RE: **Shawn McWethy Park – Phase I
Grading Plan
Engineer's Stamp Date 5/17/17
Hydrology File: J09D023A**

Re: Shawn McWethy Park – Phase 1, J09D023A Hydrology Resubmittal

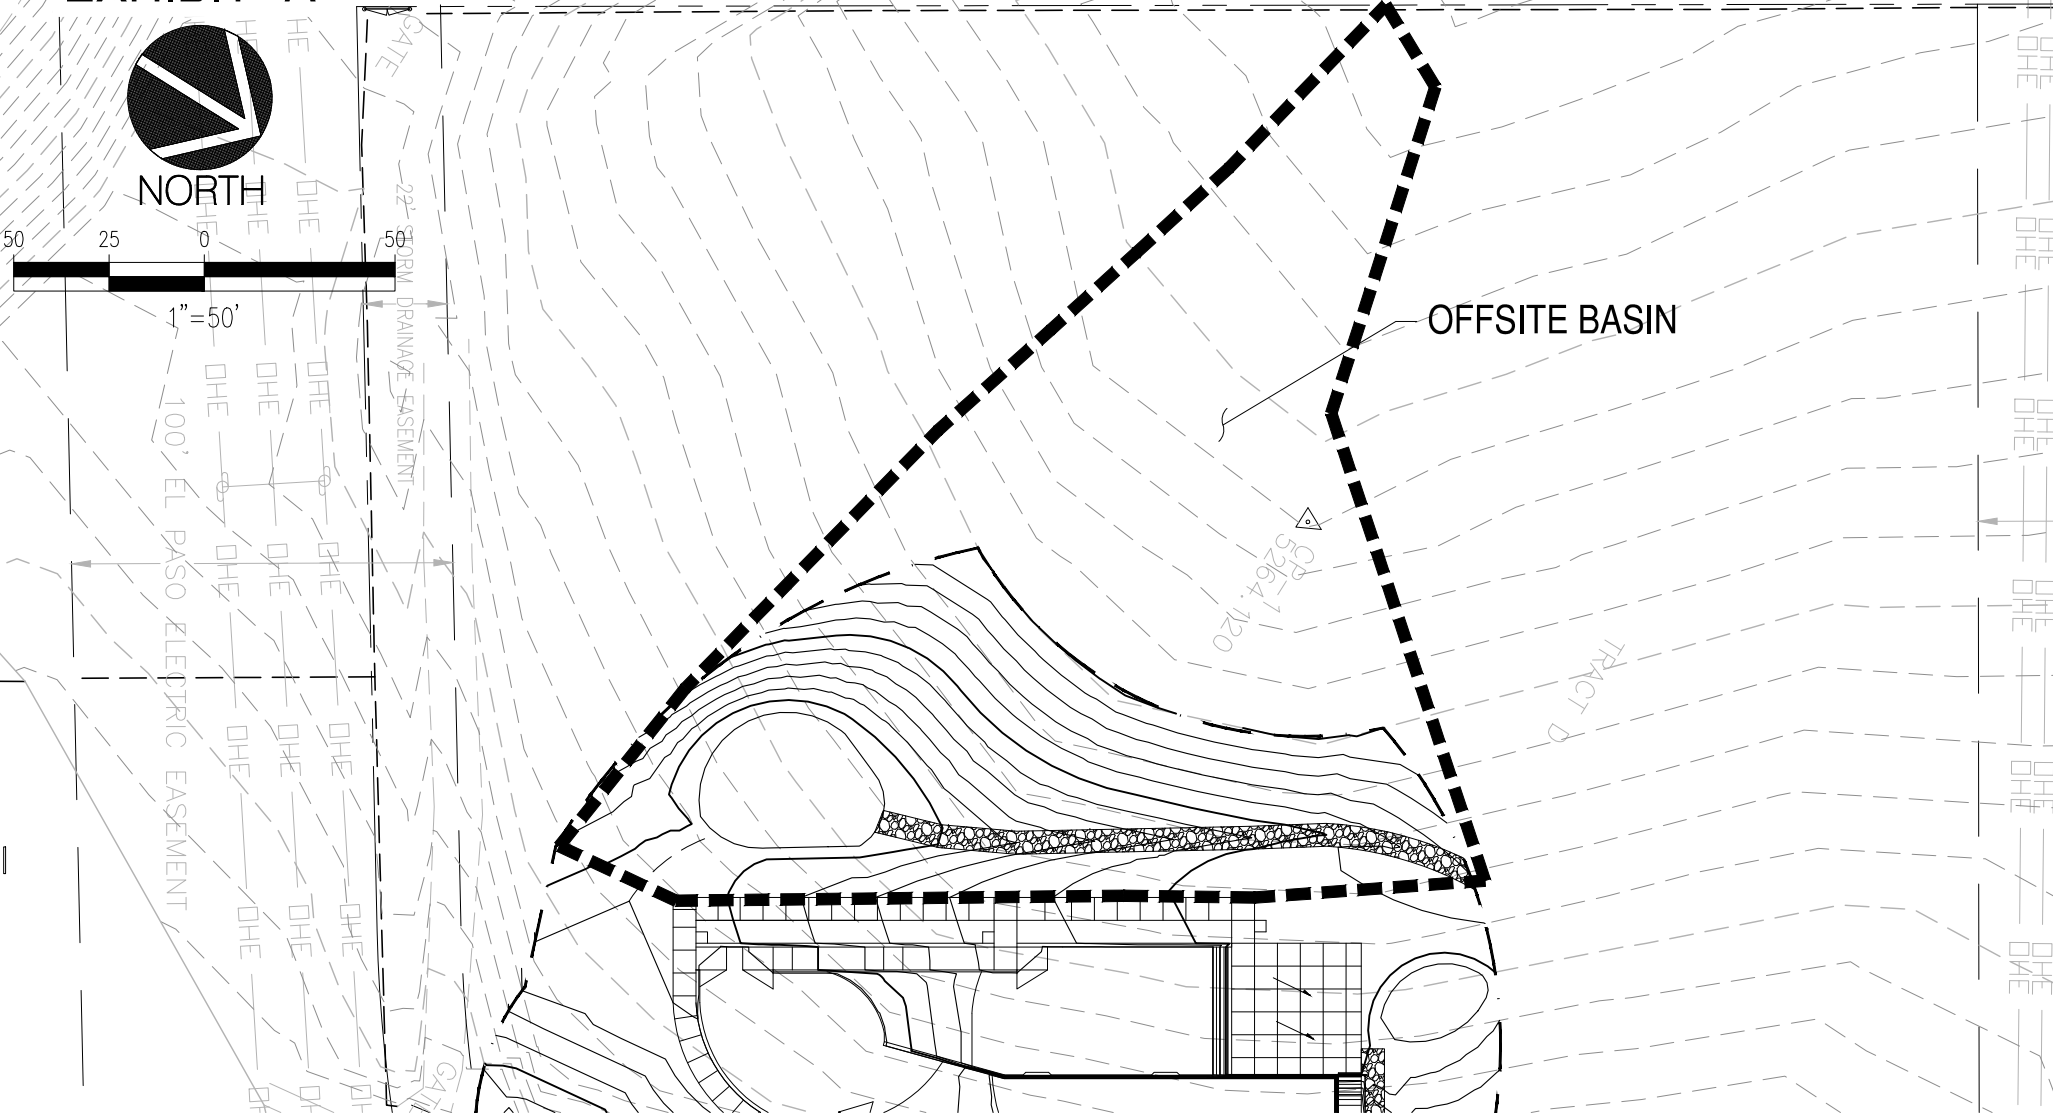
Enclosed for your review is a copy of the Revised Grading Plan for the above referenced project. The revisions are based on comments that you provided in your letter dated April 27, 2017. Below is a brief description of how the comments were addressed:

1. The western swale was incorrectly called out as Keynote 8 rather than Keynote 6, this has since been corrected and should clarify differences between the swales. Additional details have been added to Swale Section A-A for clarity as well.

2. The pond volume is now more accurately shown. The 5250 contour has now been fixed as well to provide positive drainage to the south of the proposed sidewalk.

3. The swale has been extended north to divert offsite flows as suggested.
4. The North Pond volume is now provided. This pond is used to retain a portion of the first flush volume and to help prevent nuisance flows from causing erosion.

5. The flowline is now accurately shown on the plans and no longer flows along the sidewalk.
6. Volume and runoff calculations for the offsite basin have been provided in Exhibit "A".

7. The entire site has a Required First Flush Volume of approximately 177 CF. The First Flush Volume will be retained in the playground fibar mulch as described in the Approved Drainage Management Plan for the entire park. The fibar mulch within the playground is depressed approximately 14" throughout. The North Pond also retains a portion of the First Flush Volume as well.
